## PLANNING POLICY

**TO:** Council  
**DATE:** September 14, 2021 **DIVISION:** 8  
**FILE:** 05618039/05619004/006/054 **APPLICATION:** PL20170153  
**SUBJECT:** Emergent; Amending Bylaw – Bylaw C-7991-2020 (Ascension Conceptual Scheme)

**APPLICATION:** To adopt the Ascension Conceptual Scheme to provide a policy framework to guide future redesignation, subdivision and development proposals within SW/SE-19-25-02-W05M.

Figure 18 - Regional Storm Water Servicing Plan

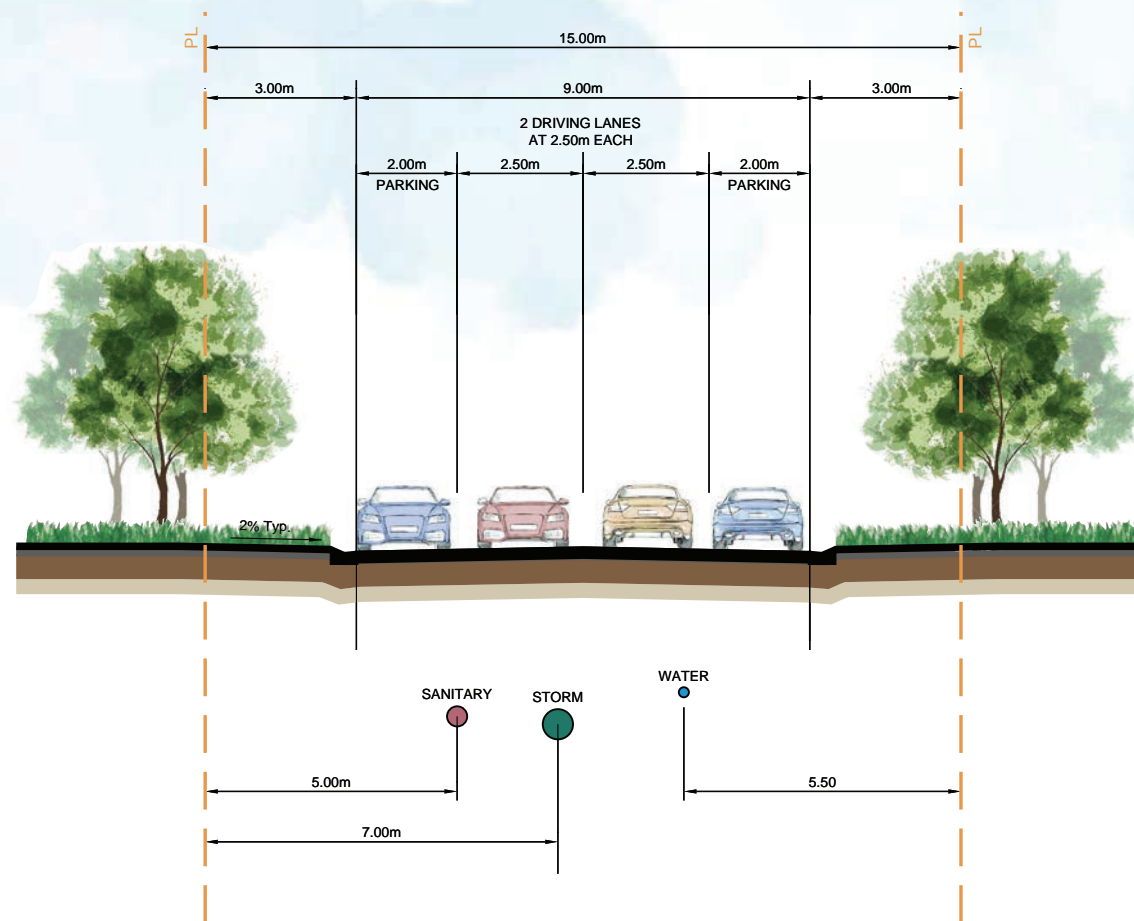
*Notwithstanding the stormwater concept identified in Figures 18 and 19 of this Conceptual Scheme, the applicant, in collaboration with Rocky View County and the City of Calgary, and prior to land use amendment and subdivision, shall explore alternative stormwater infrastructure routing that discharges to the Bow River, downstream of the Bearspaw Reservoir and Water Treatment Plant. The applicant shall specifically investigate the utilization of available capacity within the stormwater infrastructure of the Watermark development as the preferred stormwater solution for the Ascension development. To achieve a stormwater management solution that is acceptable to both Rocky View County and the City of Calgary, mechanisms such as agreements on monitoring and infrastructure improvements may be necessary.*

A principal concern raised by the City on this and other applications in Bearspaw and Springbank relates to impacts on the source watershed of the Bearspaw Reservoir and Water Treatment Plant. The current stormwater concept proposes discharge to Bow River upstream of the Reservoir, but with strict controls over stormwater quality, flows and volume. Detailed stormwater design and mitigation would be approved at subdivision stage in accordance with County and provincial requirements. Notwithstanding the validity of the current stormwater concept, the above policy directs the Applicant to explore alternative concepts that would discharge downstream of the reservoir to limit source water risks further. It further directs that further agreements on items such as monitoring may be required to ensure the stormwater solution is acceptable to both the County and City.
